## DEVELOPMENT APPLICATION ASSESSMENT REPORT

<b>Application Number:</b>	DA2021/0476
----------------------------	-------------

<b>Responsible Officer:</b>	Thomas Burns
<b>Land to be developed (Address):</b>	Lot 16 DP 11214, 21 Gurney Crescent SEAFORTH NSW 2092
<b>Proposed Development:</b>	Alterations and additions to Dwelling House
<b>Zoning:</b>	Manly LEP2013 - Land zoned R2 Low Density Residential
<b>Development Permissible:</b>	Yes
<b>Existing Use Rights:</b>	No
<b>Consent Authority:</b>	Northern Beaches Council
<b>Delegation Level:</b>	DDP
<b>Land and Environment Court Action:</b>	No
<b>Owner:</b>	James Andrew Wealleans
<b>Applicant:</b>	The Site Foreman (NSW) Pty Ltd

**Figure 1:** section plan highlighting the proposed building height non-compliance.

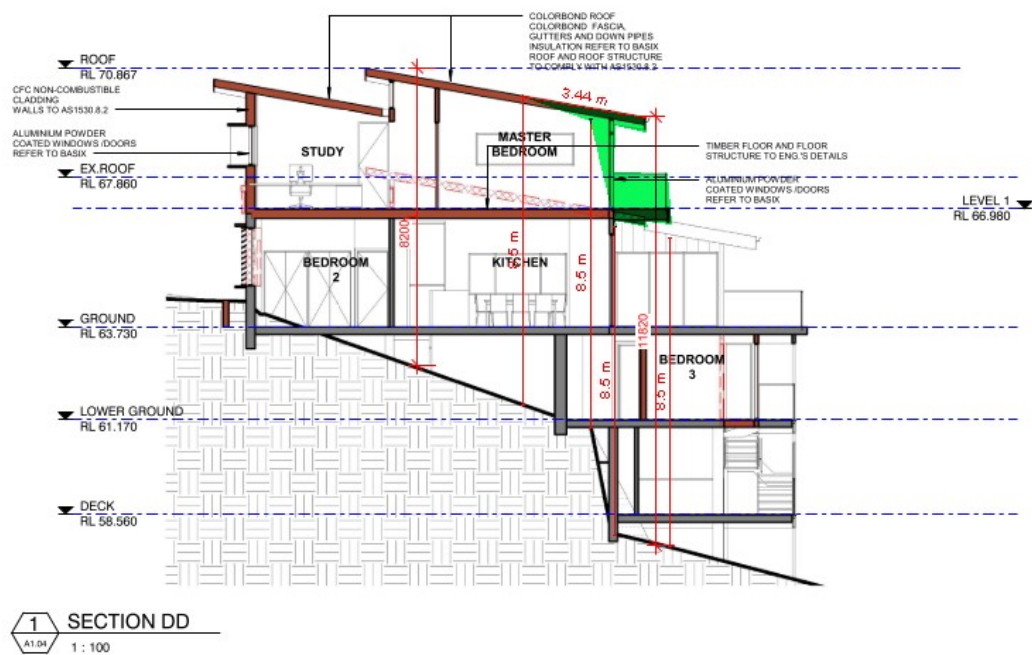
The site is subject to an 8.5m maximum building height under the requirements of Clause 4.3 of Manly LEP 2013. The proposed development contains a maximum building height of 11.82m, which represents a 39.06% variation from the Development Standard.

The extent of the new non-compliance is confined to portions of the upper floor roofline and the proposed rear balcony adjacent to the bedroom on the upper floor.

It is noted that portions of the existing dwelling's roofline currently exceeds the 8.5m height limit.

Figures 1 and 2 below demonstrate the area of the development that exceeds the 8.5m statutory height limit.
